Proposal for the MTF ILdd Mask

Sam Kocsis, Amphenol (and Editor of Annex 179B)

February 2025

Figure 179B-2—Mated test fixtures insertion loss

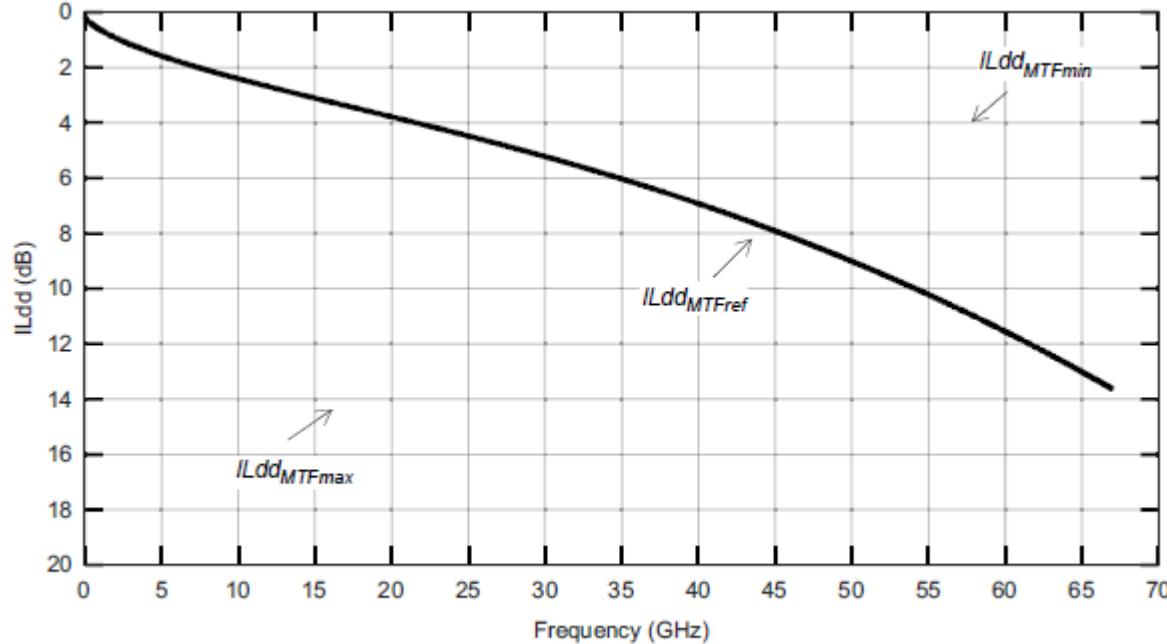
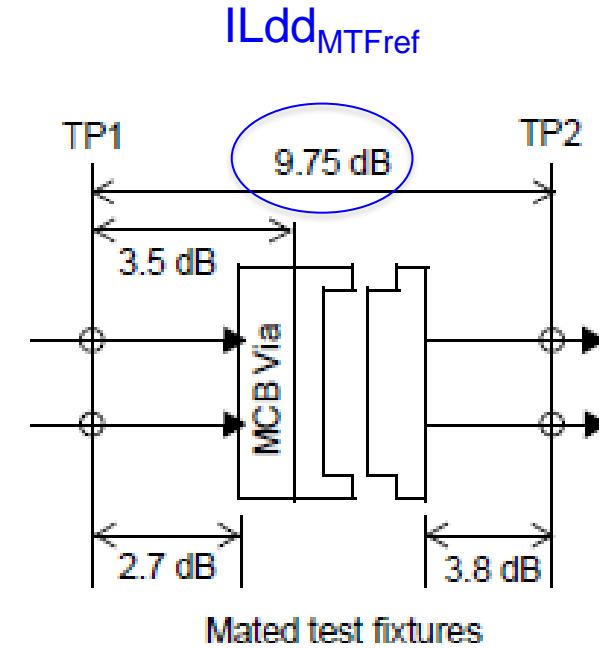
$$ILdd_{MTFref}(f) = 0.0051f^2 - 0.0509f^{1.5} + 0.2379f + 0.3153\sqrt{f} + 0.1298 \quad (179B-5)$$

Proposed Mated Test Fixture ILdd Mask

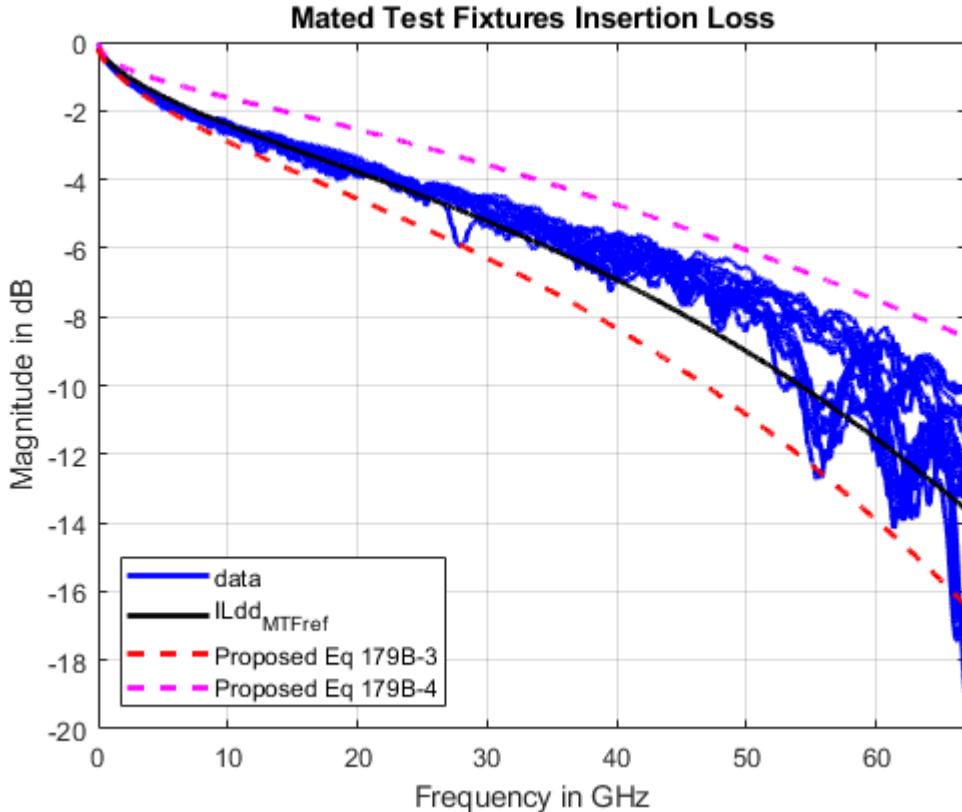
- Contributions
 - sekel_3dj_01_2407
 - mellitz_3dj_01_2501
- FOM_ILD limit is set to 0.15dB
- Precedence from prior projects (802.3ck)

Derived from PCB-based fixtures with no MDI connector

Extrapolated from factors above

$$0.0061f^2 - 0.0613f^{1.5} + 0.2867f + 0.3799\sqrt{f} + 0.1564$$

$$0.0175f^{1.5} + 0.0918f + 0.5166\sqrt{f} - 0.0294$$
